Keyless Entry Remote - Dead Batteries

TSB No.: TS 08-01 02250

DEAD BATTERIES IN KEYLESS ENTRY REMOTE "FOBS"

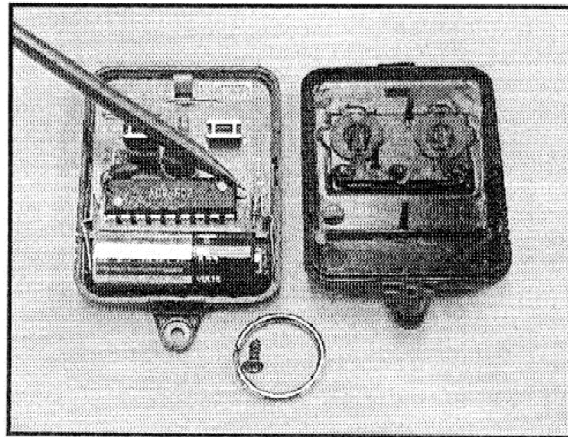
1. The illustration above shows the two types of outer housing used for the remotes. ONLY the cases with the WHITE letters MAY be affected. To determine exactly which key fob has the defective Zener diode, the key fob case must be opened.

For all instances of dead batteries in fobs with BLACK raised letters, replace the battery only. Use a No. 23A, 12 volt battery (P/N 99980-47200-005).

- 3a. Close up of the Zener diode.

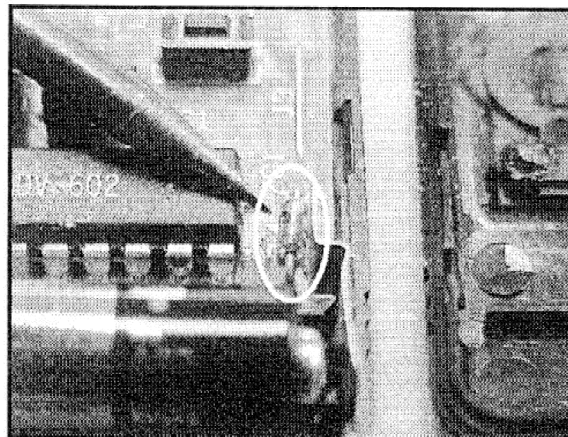
3. With the case apart, locate the Zener diode as indicated by the pointer in the picture to the right.

If the diode is RED, replace the entire key fob P/N # 99980-47200-004 and reprogram the new key fob to the control module as shown in the system owners guide.

If the diode is GREEN, replace the BATTERY ONLY. **Note** the proper direction of battery installation. Use a No. A23, 12 volt battery only (P/N # 99980-47200-005).
